## **Addendum to H-58-11-ASAM-03**

### **ENERGY ATTENUATING SEAT WIRE ALIGNMENT**

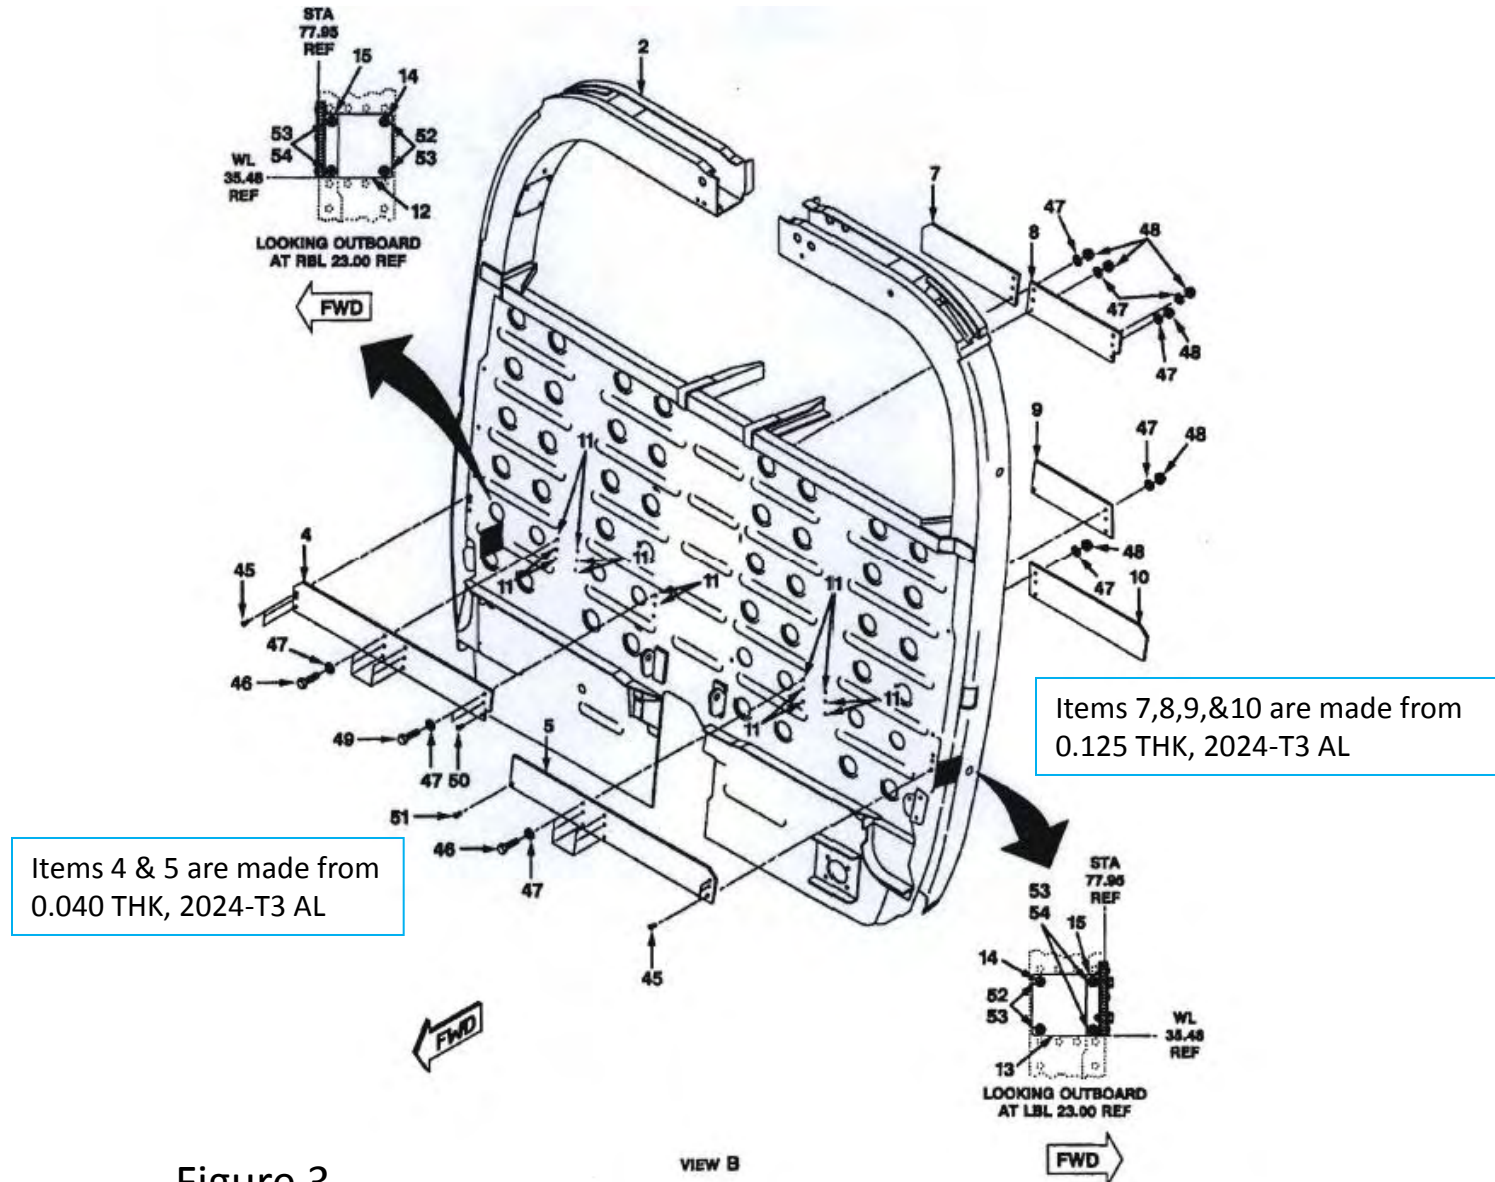
1. Gain access to the aft side of the seat bulkhead and remove seatback armor.
2. Remove roller assemblies (39), View E on Page 10, and doublers (4, 5, 7, 8, 9, 10) as required, View B on Page 7.

3. Using the removed doublers as a template, fabricate new doublers IAW the instructions provided in View B on Page 7. Match drill all holes in the new doublers EXCEPT roller bracket assembly holes. (4) Temporarily install doublers using cleco fasteners.

8. Remove doublers (4, 5, 7, 8, 9, 10) as required, View B on Page 7, to clean and deburr all holes.

10. Install doublers (4) and (5) on bulkhead (2) with six rivets (45) (three per each doubler), View B on Page 7, as required.

11. Install doubler (7) on bulkhead (2) with three bolts (46), six washers (47), and three nuts (48), View B on Page 7, as required.
12. Install doubler (8) on bulkhead (2) with 3 bolts (46), 2 bolts (49), 10 washers (47), and 5 nuts (48), View B on Page 7, as required.

13. Install doubler (9) on bulkhead (2) with three bolts (46), six washers (47), and three nuts (48), View B on Page 7, as required.
14. Install doubler (10) on bulkhead (2) with three bolts (46), six washers (47), and three nuts (48), View B on Page 7, as required.

15. Install rivet (50) in doubler (4), View B on Page 7, as required.
16. Install rivet (51) in doubler (5), View B on Page 7, as required.
17. Install angles (12) and (13) on frame with two screws (52) and washers (53) per angle (aft holes), View B on Page 7, as required.

18. Install two radius blocks (15) (one each) on angles (12) and (13) and frame with two screws (54) and washers (53) per radius block, View B on Page 7, as required.

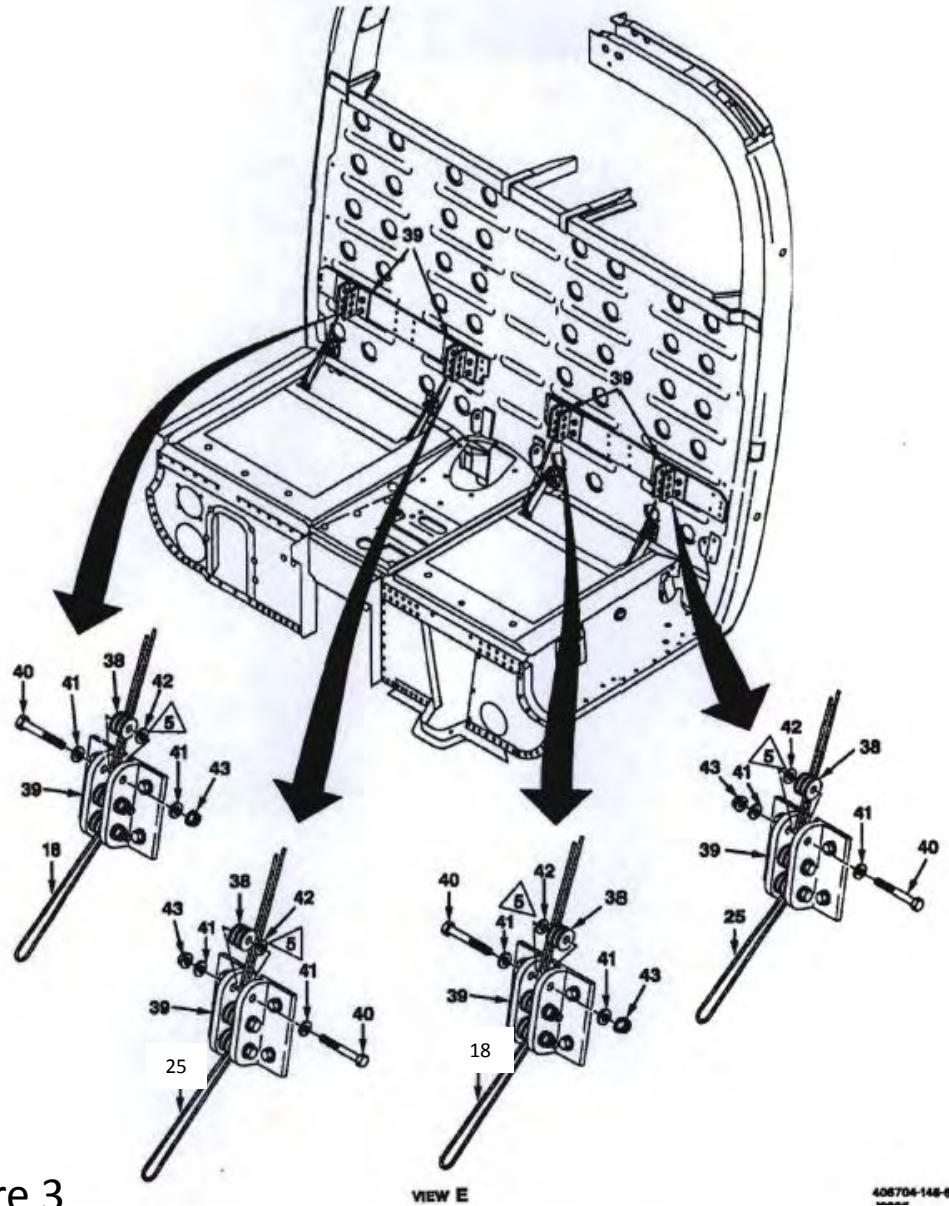
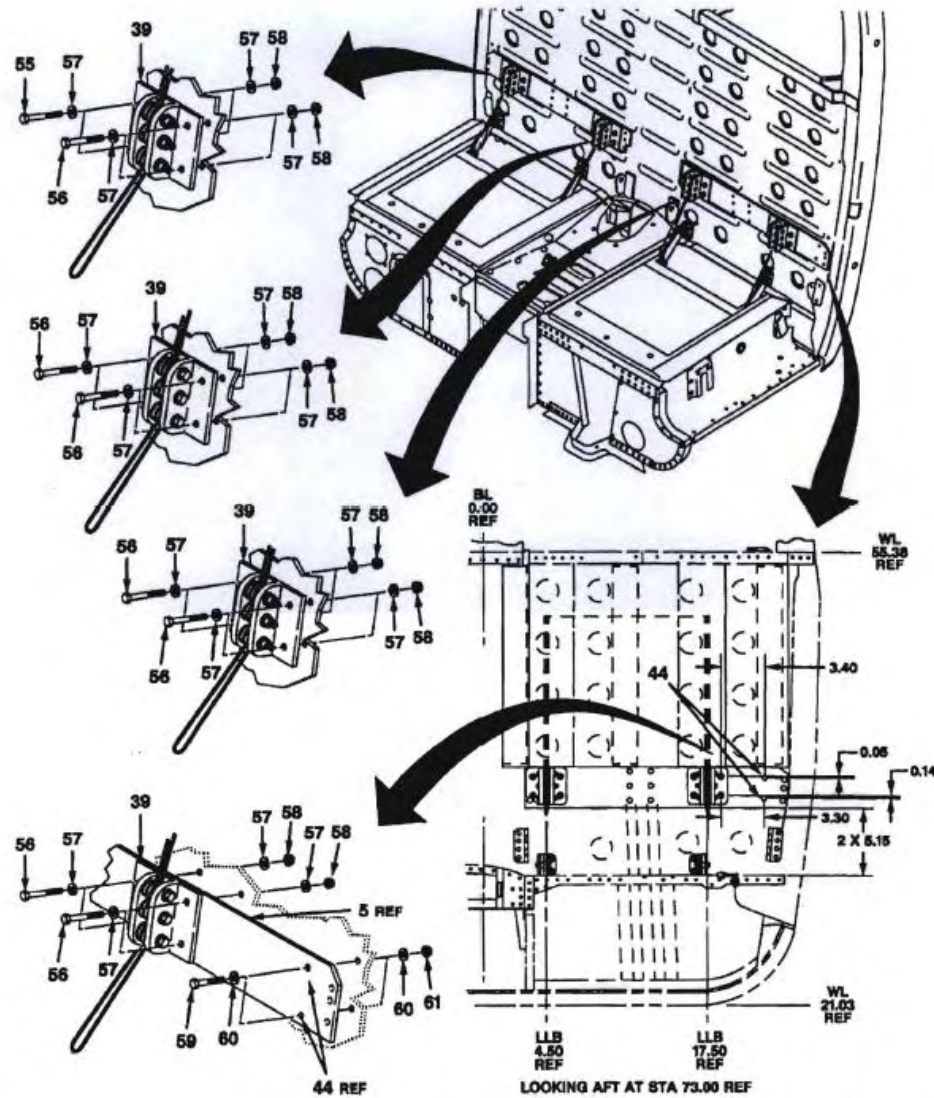
4. Install center roller (38) in each of the roller housing assemblies (39) with bolt (40), two washers (41), washer (42), and nut (43) per roller, View E on Page 10.

5. Hold attenuating wires (18) and (25) in position on center rollers (38) and install top and bottom rollers (38) with bolt (40), two washers (41), washer (42), and nut (43) per roller, View E on Page 10.

6. Using a 0.250-inch diameter bit, match drill holes (four each) to holes in roller housing assemblies (39), View D on Page 9.
7. Remove nuts (43), washers (42), washers (41), and bolts (40) and rollers (38) from roller housing assemblies (39), View E on Page 10.
